KNIT Concern Ltd. (9499)

No. 62, Water Works Road, Godnail Narayanganj – 1400, Dhaka Division, Bangladesh
(+23.641536N, +90.514255E)

07.APRIL.2014

1st Priority 2 Concern

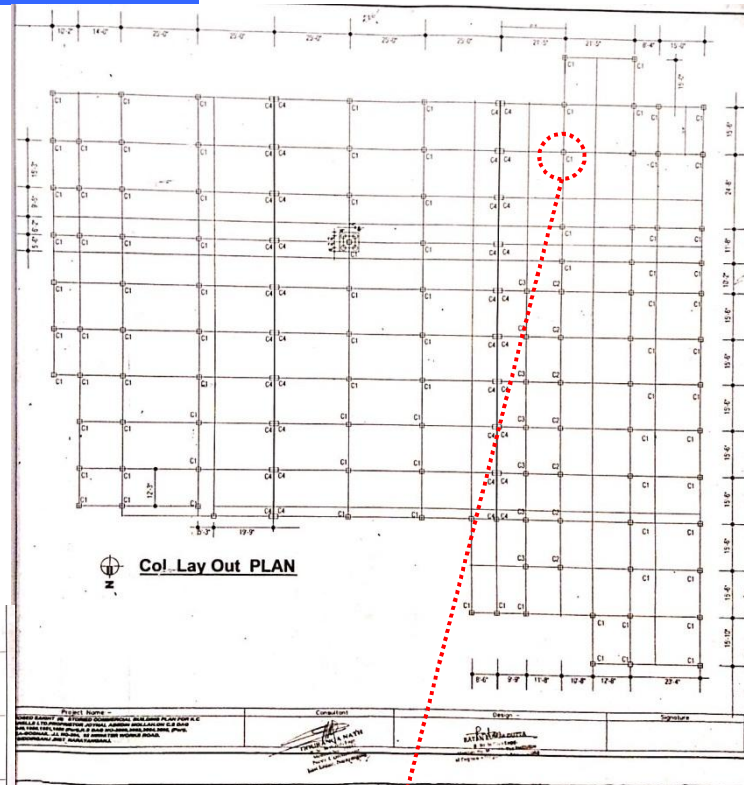
Column to be checked

Based on the load rundown analysis with the agreed minimum design live load assignment, the column in the clouded area seems significantly inadequate to carry the dead and live loads, giving a firm AMBER warning. The building was constructed before 2005, with brick aggregate.

- Reduce the loads on all levels at the mentioned column location.
- Building engineer to review the design of the highlighted column.

- Cores should be taken to verify the actual in-situ concrete strength, to allow a review the design.

1st Priority 3 Concern

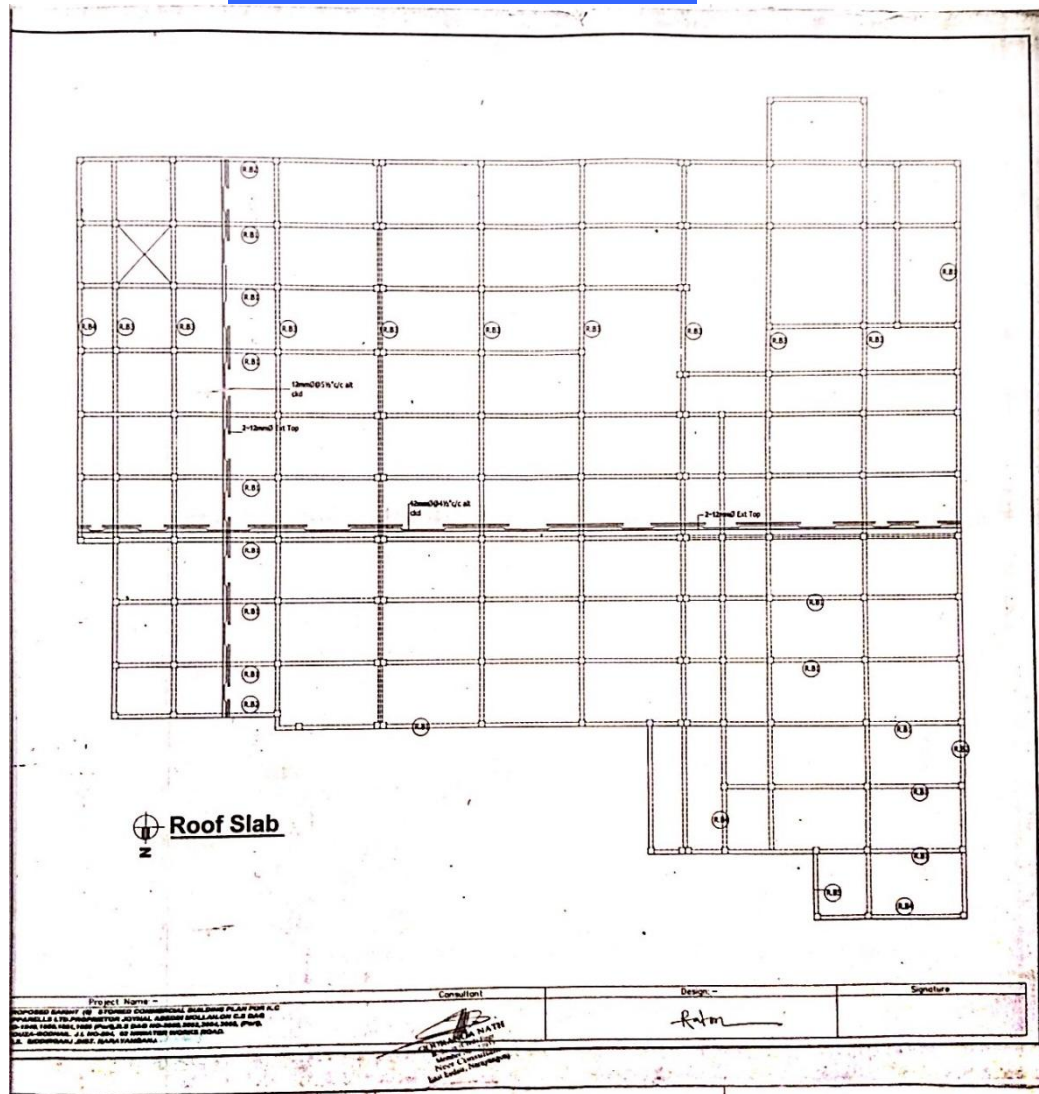
The structural design show the perimeter beams on all sides of the building. However, the as-built structure does not have these beams.

No perimeter beams

- Lack of perimeter beam needs to be investigated structurally to check long term deflections or any effects on the slab.
- Building engineer to check and provide the solution for lateral resisting requirements of the structure.

3th Priority 3 Concern

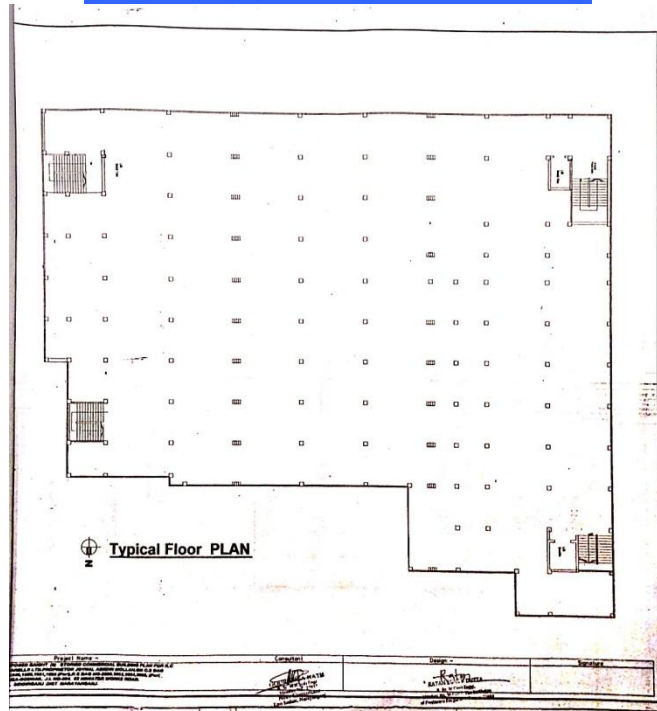
No cantilever from the original design

The slab cantilevers from level 2 to the roof level were not as designed. No record of these extensions is made on any drawings

- Carry out full building survey using both intrusive and non-intrusive techniques.
- Carry out concrete strength test of structural elements to determine concrete strength.
- Building Engineer to fully check loading capacity of all components modified on site without any structural approval to establish whether or not the as-built components are able to sustain the loading.

- Based on the building survey, develop full structural records, and also propose strengthening works or repair works if the as-built structure appears to be insufficient in any way.

4th Priority 3 Concern

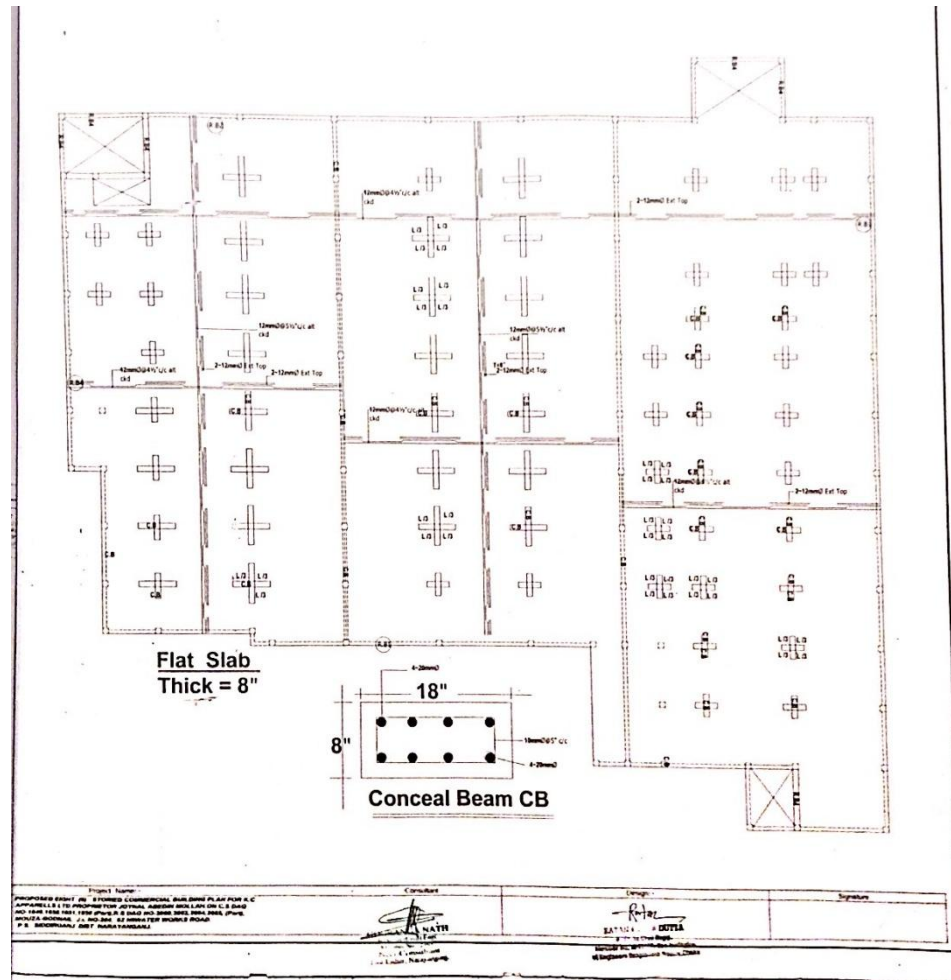
The set of structural drawings is not consistent with the as-built structure. It is necessary to check a full structural analysis of the building to establish the validity of the site conditions.

The structural drawings must be revised in order to reflect the actual site conditions.
